Re: **Revision to COMBINED STORMWATER  
MANAGEMENT CONCEPT/SITE  
DEVELOPMENT STORMWATER  
MANAGEMENT PLAN** for Crystal Rock  
Project Phase: Black Hill Townes  
Preliminary Plan #: 12012021D  
Site Plan #: 820240100  
SM File #: 242487  
Tract Size/Zone: 5.74 Acres/CR-0.75,C-0.5,R-  
0.5,H-145T  
Total Concept Area: 5.62 Acres/244,810 sq.ft.  
Parcel(s): F  
Watershed and Class: Little Seneca Creek/IV  
Redevelopment (Yes/No): No

RE: Preliminary Plan No. 12012021D  
Black Hill  
Preliminary Plan Letter

**SIGHT DISTANCE EVALUATION**

**DATE:** 06-Mar-25  
**TO:** Patrick La Vay - plavay@mhgpa.com  
Macris, Hendricks & Glascock  
**FROM:** Marie LaBaw  
**RE:** Black Hill Townes  
820240100

SIGHT DISTANCE & STREET PARKING EXHIBIT  
MEASURED 6' FROM EXISTING CURB LINE

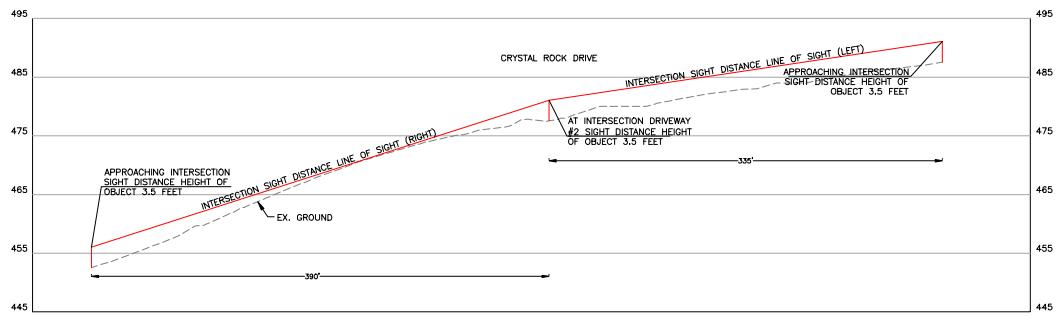
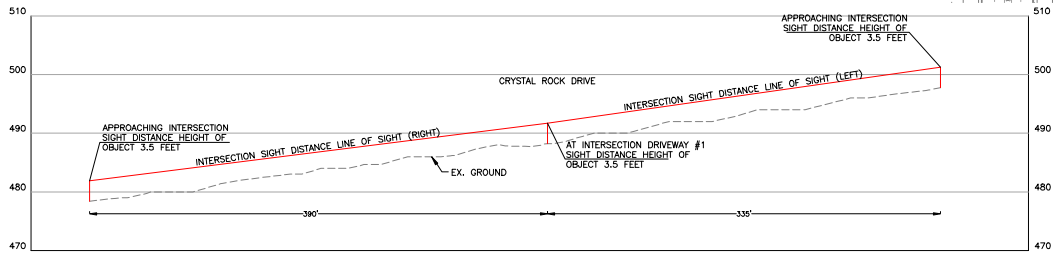
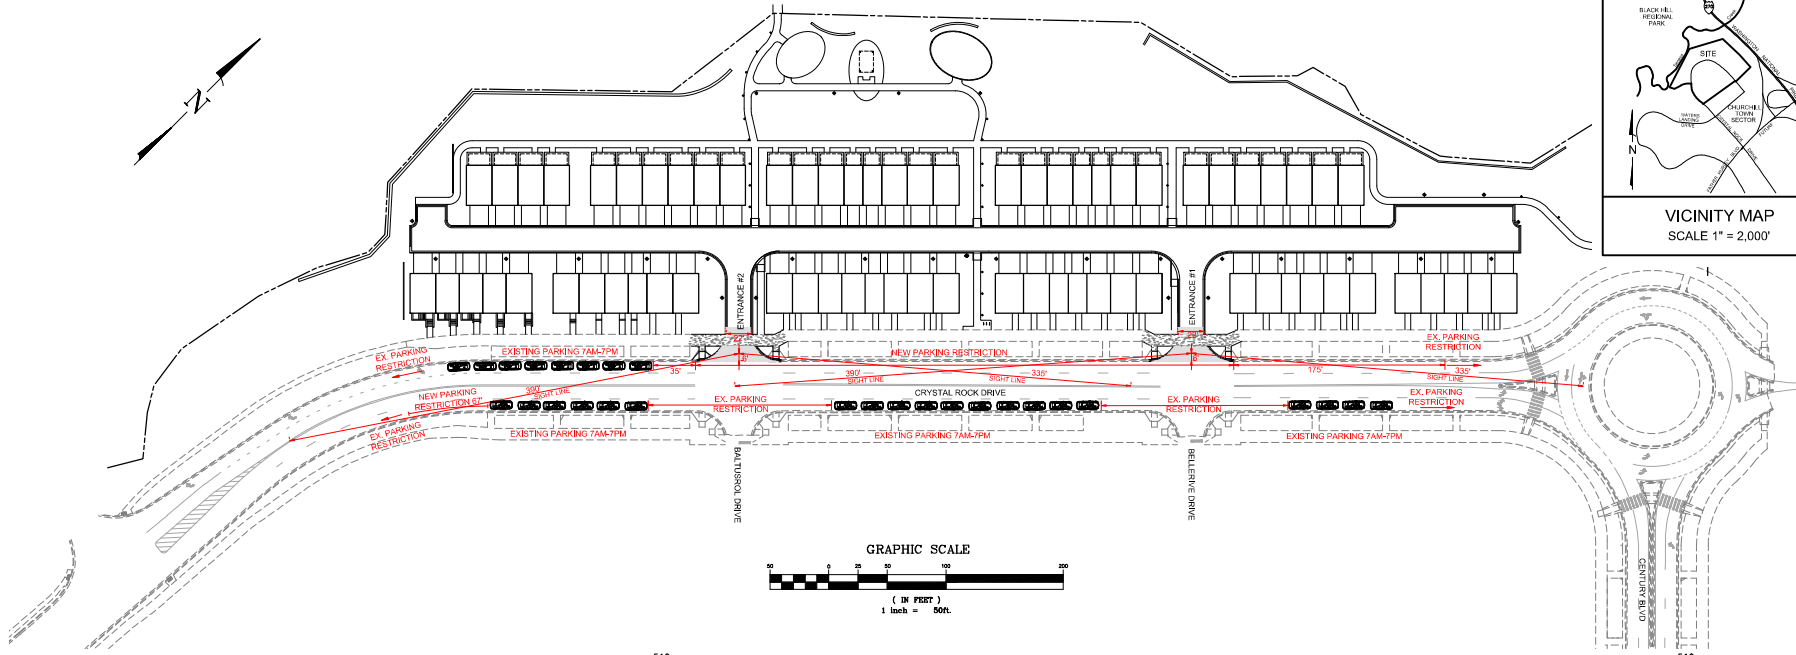
* Looking left at 250' is the existing traffic circle of Crystal Rock Dr and Century Blvd; vehicles will be traveling below the posted speed limit through and out of the traffic circle. Bioretention plantings should be kept trimmed to below the sight line or replaced with lower ground cover plantings.

* 360' from entrance is inside the truck apron of the existing traffic circle			
No parking signs required as shown on the included exhibit.

**SITE PLAN  
820240100  
FIRE DEPARTMENT  
ACCESS PLAN  
SP-023**  
PROJECT NO. 10.102.39  
SHEET NO. 2 OF 2

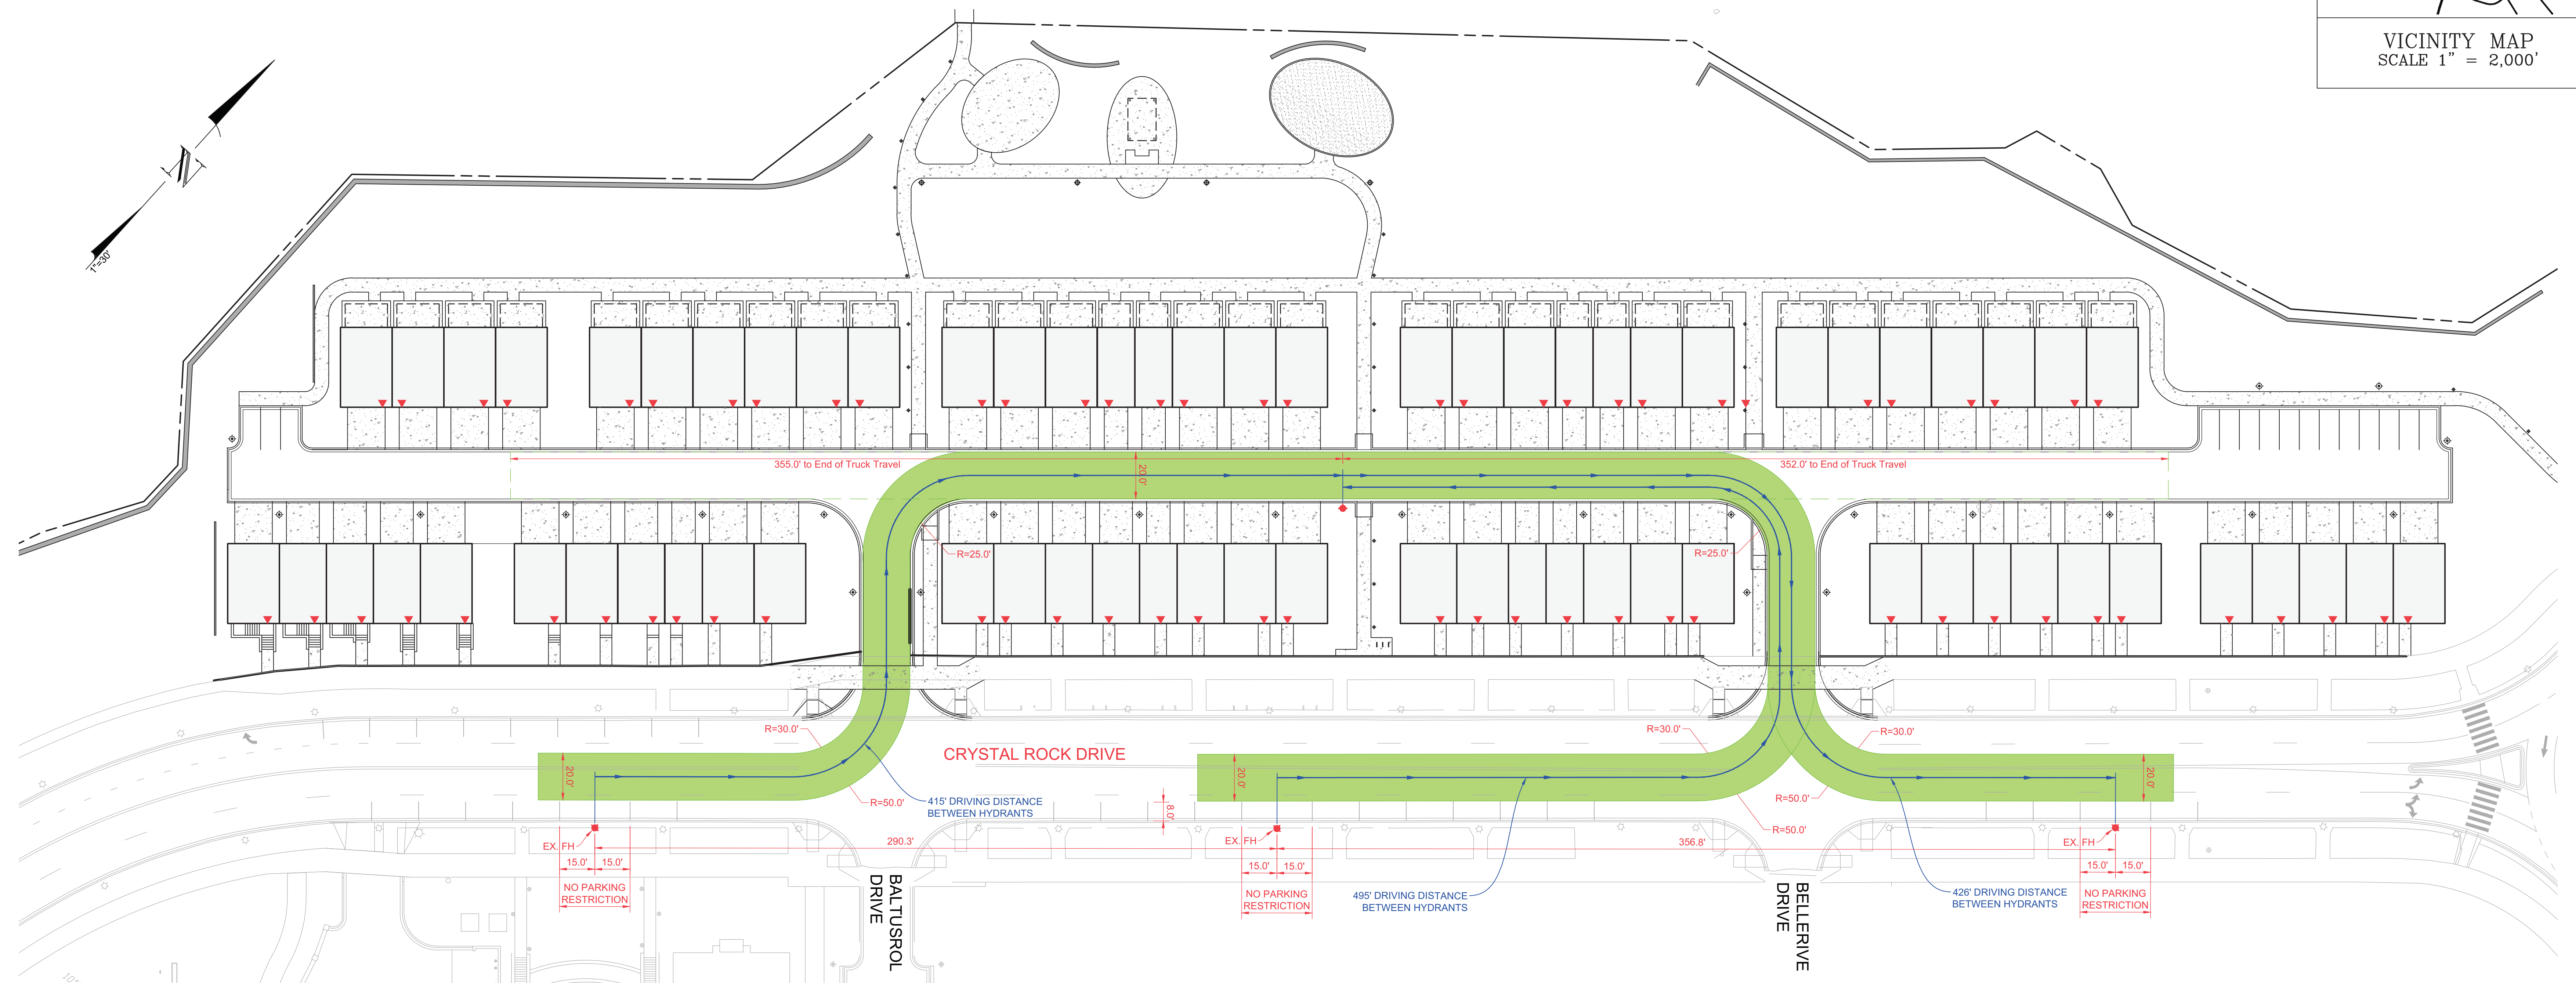
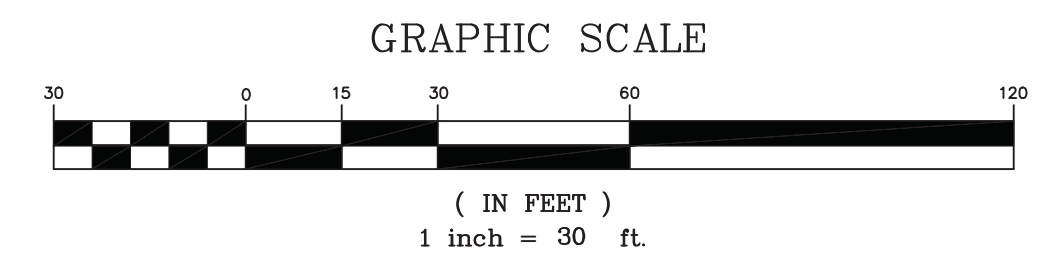
**\*\*\* Parking restrictions required on Crystal Rock to make existing hydrants compliant for new development \*\*\***

Parking is as shown on Fire Access Plan Sheets SP-022 and SP-023 of Site Plan # 820240100.

1. West side of Crystal Rock Drive, beginning at Baltusrol Drive to 270 feet south of Baltusrol Drive.
2. West side of Crystal Rock Drive, between Baltusrol Drive and Bellerive Drive.
3. West side of Crystal Rock Drive, from Bellerive Drive to the traffic Circle where Crystal Rock Drive meets Century Boulevard.
4. East side of Crystal Rock Drive, within 15 feet (either direction) of existing fire hydrants located immediate south of Baltusrol Drive, between Baltusrol Drive and Bellerive Drive, and immediately north of Bellerive Drive.
